AGENDA (Part 1)

DHCD WORKGROUP MEETING 2012 Code Change Cycle

August 22, 2013 at 9:30

Figure 2. Post-test condition of an exterior wall assembly.

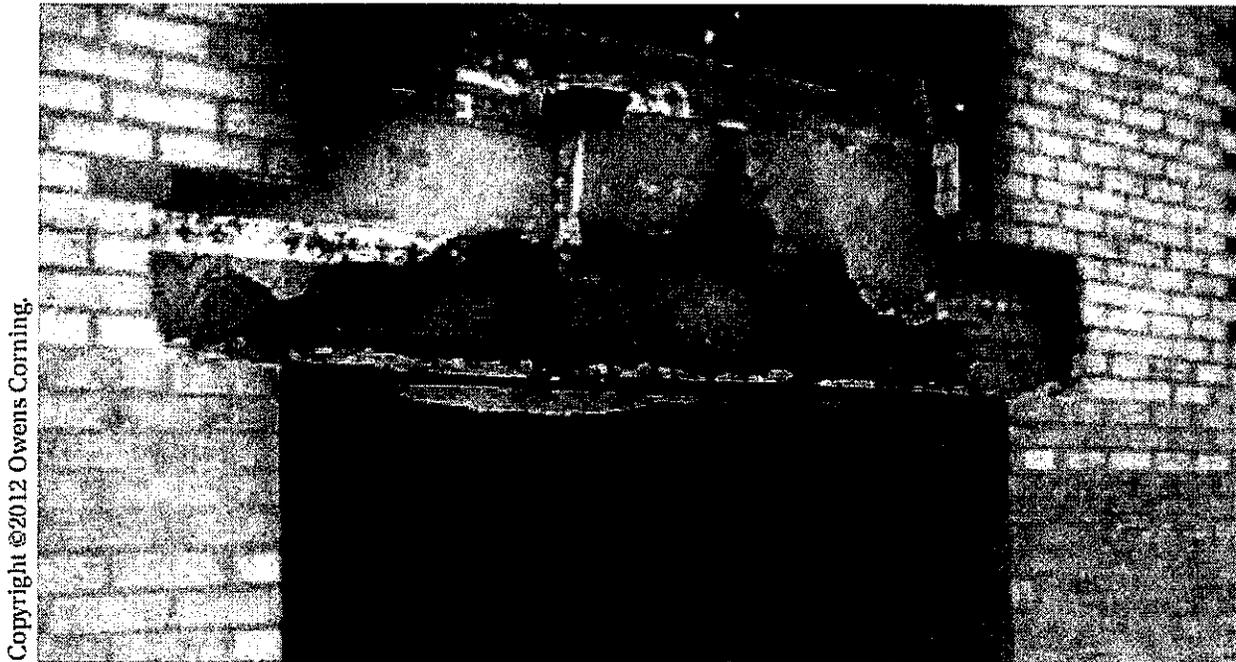
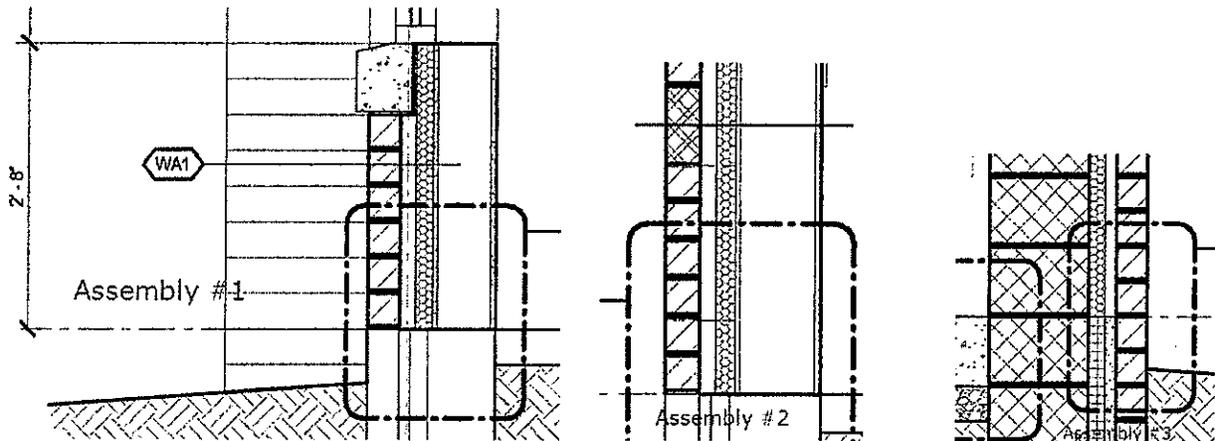
However, NFPA 285 1.1.1 - Scope states, "This standard provides a test method for determining the fire propagation characteristics of exterior non-load-bearing wall assemblies and panels used as components of curtain wall assemblies, **constructed using combustible materials or that incorporate combustible components**, that are intended to be installed on buildings required to have exterior walls of noncombustible construction."

- Therefore, requiring multiple tests because noncombustible materials are changed or varied within an assembly appears to run contrary to the purpose and scope of the test. In photos of tests with noncombustible materials, they remove the noncombustible materials so they can determine the scope of propagation of the *combustible* component(s).

- It would appear the emphasis is not on the "structural" component of the exterior wall (e.g., CMU or steel stud framing) or an exterior finish (e.g., facebrick or, precast), especially if those materials were noncombustible. Therefore, if one of those materials changed from or within one exterior wall assembly to another, it should not be grounds to require another NFPA 285 test.

- The proposed code change includes text addressing the above. In other words, if a building has two assemblies, and the only difference is that one has CMU backup wythe and the other has gypsum sheathing + steel studs + gypsum drywall backup wythe (all are noncombustible materials), a second NFPA 285 test would not be required. Or, if the only difference was one assembly had facebrick and the other had split-face CMU as the covering/veneer, a second NFPA 285 test would not be required.
 - Refer to the examples below: The accent band of split-face CMU in Assembly #2 would require a second NFPA 285 test, and the change from steel studs/gypsum to CMU in Assembly #3 would require a third NFPA 285 test.

Figure 2. Post-test condition of an exterior wall assembly.

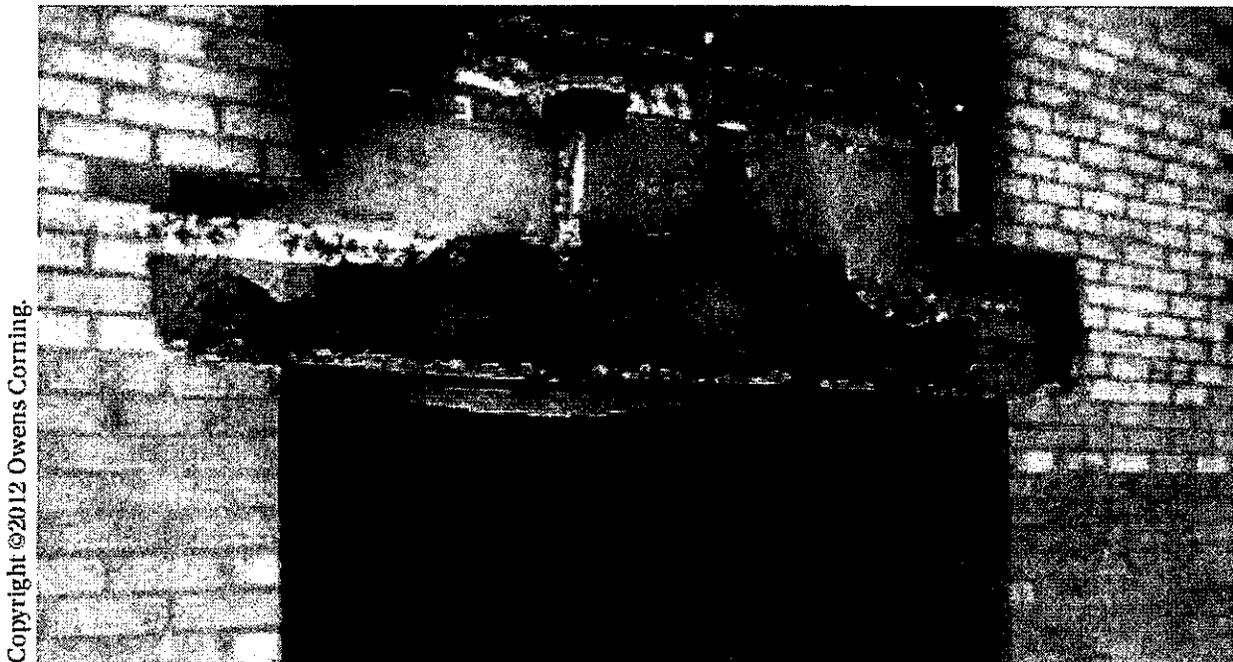
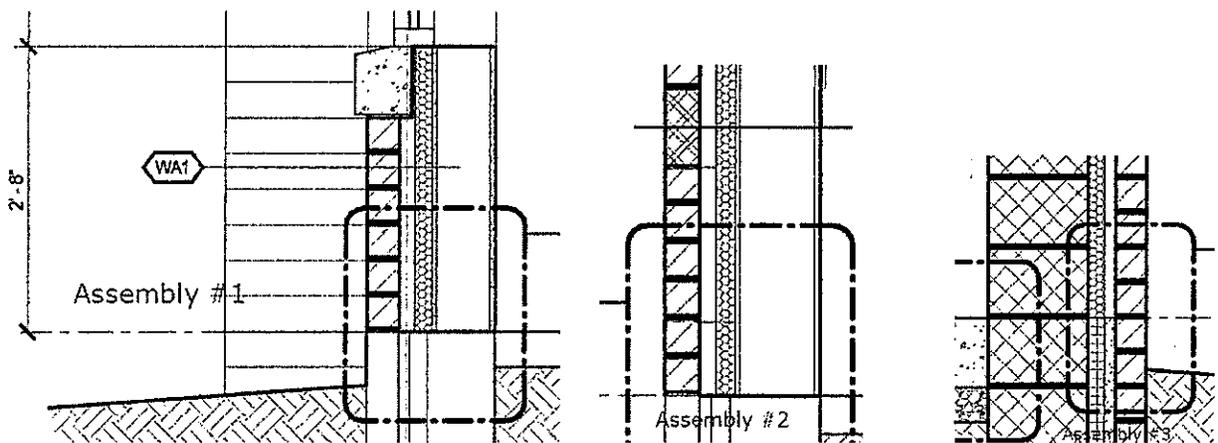
- Therefore, requiring multiple tests because noncombustible materials are changed or varied within an assembly appears to run contrary to the purpose and scope of the test. In photos of tests with noncombustible materials, they remove the noncombustible materials so they can determine the scope of propagation of the *combustible* component(s).

- The IBC currently allows a multitude of combustible materials within noncombustible construction. If one of those "exempted" materials changed from or within one exterior wall assembly to another, it should not be grounds to require another NFPA 285 test.

- It would appear the emphasis is not on the "structural" component of the exterior wall (e.g., CMU or steel stud framing) or an exterior finish (e.g., facebrick or, precast), especially if those materials were noncombustible. Therefore, if one of those materials changed from or within one exterior wall assembly to another, it should not be grounds to require another NFPA 285 test.

Figure 2. Post-test condition of an exterior wall assembly.

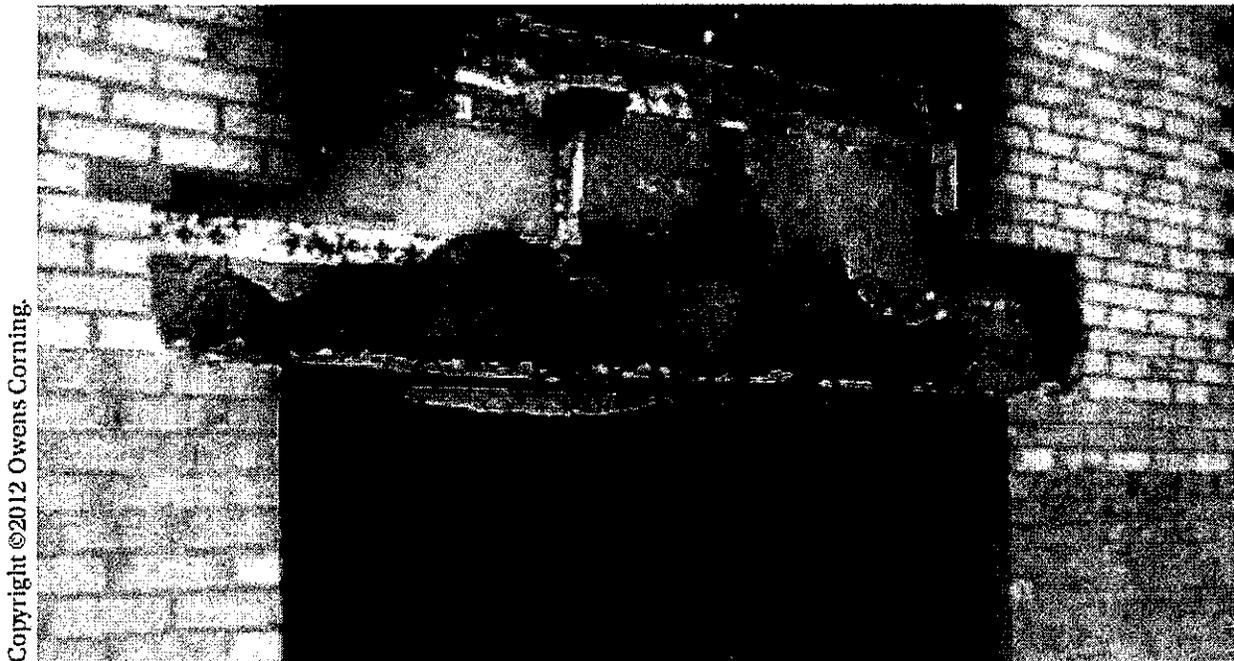
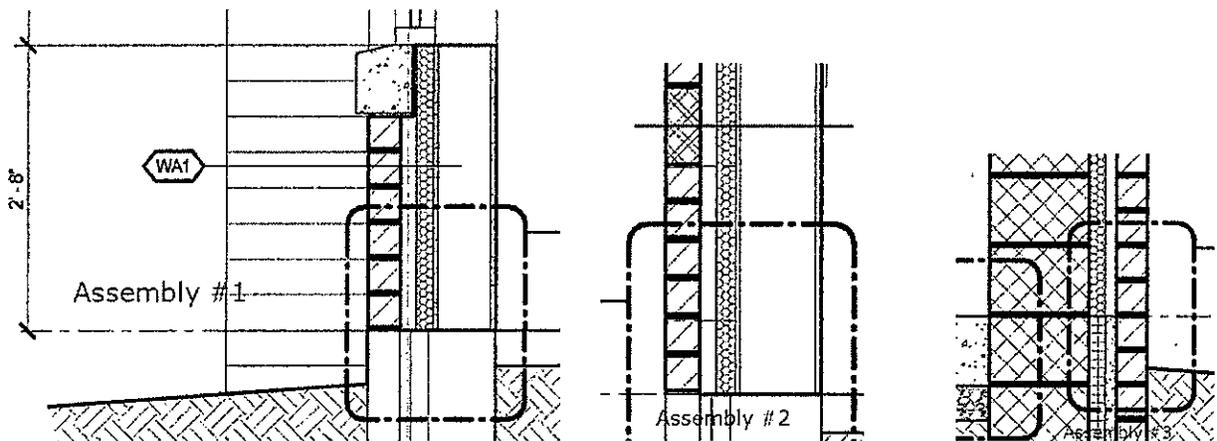
- Therefore, requiring multiple tests because noncombustible materials are changed or varied within an assembly appears to run contrary to the purpose and scope of the test. In photos of tests with noncombustible materials, they remove the noncombustible materials so they can determine the scope of propagation of the *combustible* component(s).

- The IBC currently allows a multitude of combustible materials within noncombustible construction. If one of those "exempted" materials changed from or within one exterior wall assembly to another, it should not be grounds to require another NFPA 285 test.

- It would appear the emphasis is not on the “structural” component of the exterior wall (e.g., CMU or steel stud framing) or an exterior finish (e.g., facebrick or, precast), especially if those materials were noncombustible. Therefore, if one of those materials changed from or within one exterior wall assembly to another, it should not be grounds to require another NFPA 285 test.
